RS-13-273

**Subject:** Responses to NRC Requests for Additional Information, Set 3, dated November 25, 2013, related to the Braidwood Station, Units 1 and 2, and Byron Station, Units 1 and 2 License Renewal Application

**Byron and Braidwood Stations (BBS), Units 1 and 2  
License Renewal Application  
Responses to Requests for Additional Information**

**Figure 2.1-3**

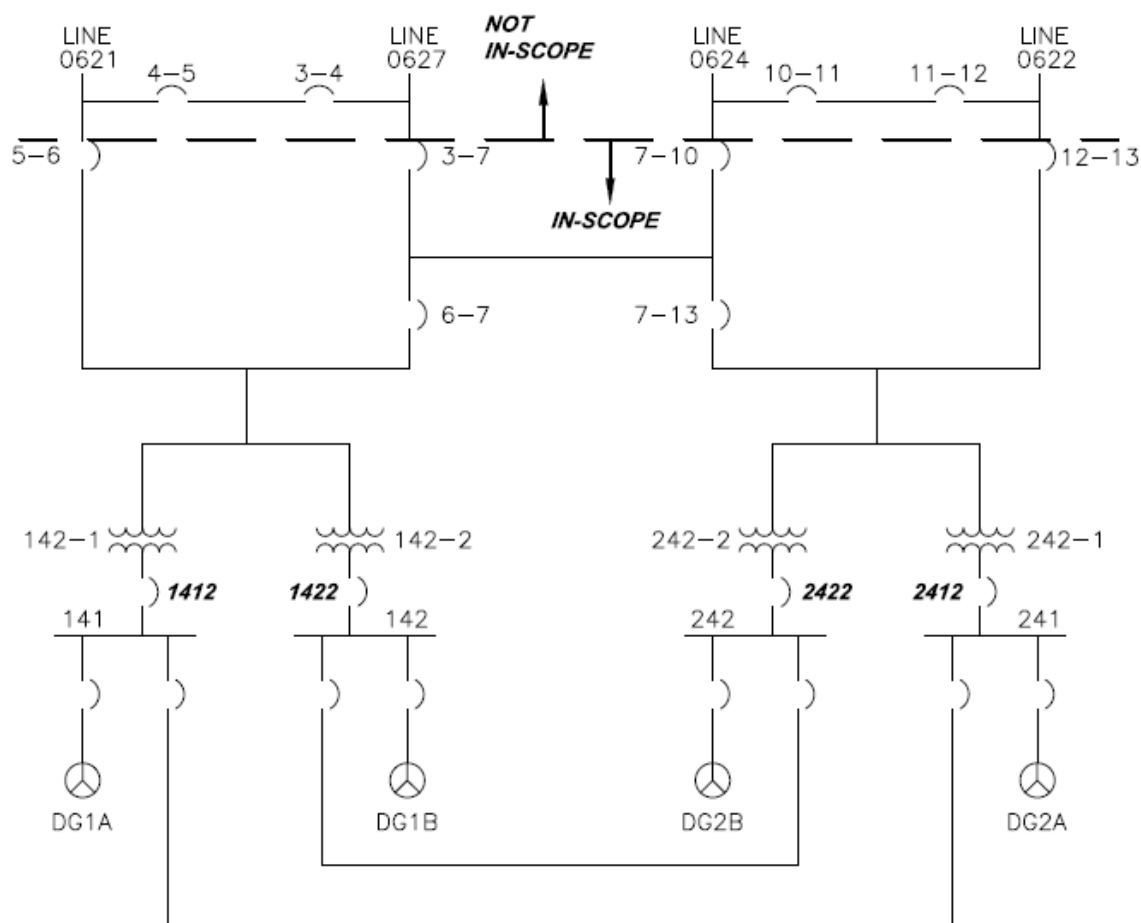
Figure 2.1-3 in the LRA, Section 2.1.3.4, which depicts the Braidwood Station Blackout (SBO) recovery boundary, does not show circuit breakers 1412, 1422, 2412, and 2422 between the 345-kV circuit breakers and the 4160-volt ESF buses.

- a. Clarify why circuit breakers 1412, 1422, 2412 and 2422 are not included in Figure 2.1-3.
- b. Confirm that all components, including breakers and disconnect switches, between the 345-kV utility grid and the 4160-volt ESF buses that are in the SBO recovery path are within the scope of license renewal.
- c. Provide a revised Figure 2.1-3, as applicable, for the Braidwood SBO recovery boundary including all components in the SBO recovery path that shows a clear distinction between components that are within the scope of license renewal and those that are not.

The applicant did not include 345-kV circuit breakers 1-3 and 9-15 in Figure 2.1-3 within the scope of license renewal.

Clarify whether the 345-kV circuit breakers 1-3 and 9-15 are within the scope of license renewal.

- a. LRA Figure 2.1-3, Braidwood Station Blackout (SBO) Recovery Boundary is a simplified representation of the Braidwood SBO recovery path. Circuit breakers 1412, 1422, 2412 and 2422 were not shown on LRA Figure 2.1-3 to maintain the figure as simple as possible. Circuit breakers 1412, 1422, 2412 and 2422 are in the Braidwood SBO recovery path and are within the scope of license renewal.

- c. Consistent with this response, LRA Figure 2.1-3, page 2.1-15, is revised as shown in Enclosure B. The revised LRA Figure 2.1-3 for the Braidwood SBO recovery boundary includes circuit breakers 1412, 1422, 2412, and 2422. Also, an explicit demarcation line that shows a clear distinction between components that are within the scope of license renewal and those components that are not in the scope of license renewal is added to LRA Figure 2.1-3.

The 345-kV circuit breakers 1-3 and 9-15 are not in the scope of license renewal. The first circuit breakers between the plant electrical distribution system and the electrical transmission network for Braidwood Unit 1 are 345-kV circuit breakers 3-4 and 4-7. The first circuit breakers between the plant electrical distribution system and the electrical transmission network for Braidwood Unit 2 are 345-kV circuit breakers 11-14 and 14-15. Circuit breakers 1-3 and 9-15 are beyond the first circuit breakers between the plant electrical distribution system and the electrical transmission network, therefore, circuit breakers 1-3 and 9-15 are not in the scope of license renewal. Consistent with this response, LRA Figure 2.1-3, page 2.1-15, is revised as shown in Enclosure B. LRA Figure 2.1-3, is revised to add an explicit demarcation line that shows a clear distinction between components that are within the scope of license renewal and those components that are not in the scope of license renewal.

As a result of the responses to RAI 2.1.3.4-3 and 2.1.3.4-4 provided in Enclosure A of this letter, LRA Figure 2.1-3, page 2.1-15, "Braidwood SBO Recovery Boundary," is revised as shown below:

**Figure 2.1-2**

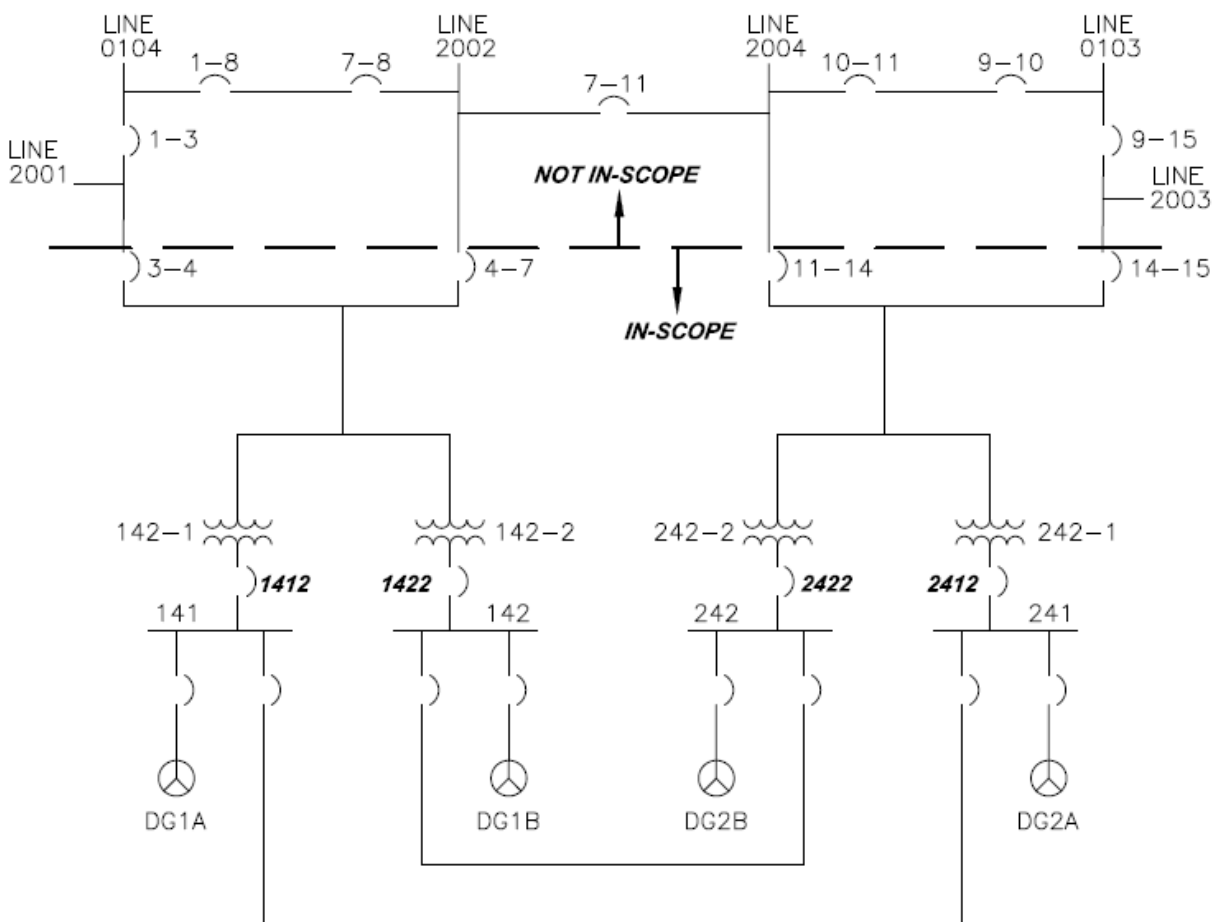
Figure 2.1-2 in the LRA, Section 2.1.3.4, which depicts the Byron Station Blackout (SBO) recovery boundary, does not show circuit breakers 1412, 1422, 2412, and 2422 between the 345-kV circuit breakers and the 4160-volt ESF buses.

- a. Clarify why circuit breakers 1412, 1422, 2412 and 2422 are not included in Figure 2.1-2.
- b. Confirm that all components, including breakers and disconnect switches, between the 345-kV utility grid and the 4160-volt ESF buses that are in the SBO recovery path are within the scope of license renewal.
- c. Provide a revised Figure 2.1-2, as applicable, for the Byron SBO recovery boundary including all components in the SBO recovery path that shows a clear distinction between components that are within the scope of license renewal and those that are not.

The applicant did not include 345-kV circuit breakers 6-7 and 7-13 in Figure 2.1-2 within the scope of license renewal.

Clarify whether 345-kV circuit breakers 6-7 and 7-13 are within the scope of license renewal.

- a. LRA Figure 2.1-2, Byron Station Blackout (SBO) Recovery Boundary is a simplified representation of the Byron SBO recovery path. Circuit breakers 1412, 1422, 2412 and 2422 were not shown on LRA Figure 2.1-2 to maintain the figure as simple as possible. Circuit breakers 1412, 1422, 2412 and 2422 are in the Byron SBO recovery path and are within the scope of license renewal.

- b. The components in the SBO recovery path between the 345-kV utility grid and the 4160-volt ESF buses, including breakers and disconnect switches, are within the scope of license renewal.

- c. Consistent with this response, LRA Figure 2.1-2, page 2.1-14, is revised as shown in Enclosure B. The revised LRA Figure 2.1-2 for the Byron SBO recovery boundary includes circuit breakers 1412, 1422, 2412, and 2422. Also, an explicit demarcation line that shows a clear distinction between components that are within the scope of license renewal and those components that are not in the scope of license renewal is added to LRA Figure 2.1-2.

The 345-kV circuit breakers 6-7 and 7-13 are within the scope of license renewal. Consistent with this response, LRA Figure 2.1-2, page 2.1-14, is revised as shown in Enclosure B. LRA Figure 2.1-2 is revised to add an explicit demarcation line that shows a clear distinction between components that are within the scope of license renewal, including circuit breakers 6-7 and 7-13, and those components that are not in the scope of license renewal.

As a result of the responses to RAI 2.1.3.4-1 and 2.1.3.4-2 provided in Enclosure A of this letter, LRA Figure 2.1-2, "Byron SBO Recovery Boundary," page 2.1-14, is revised as shown below:
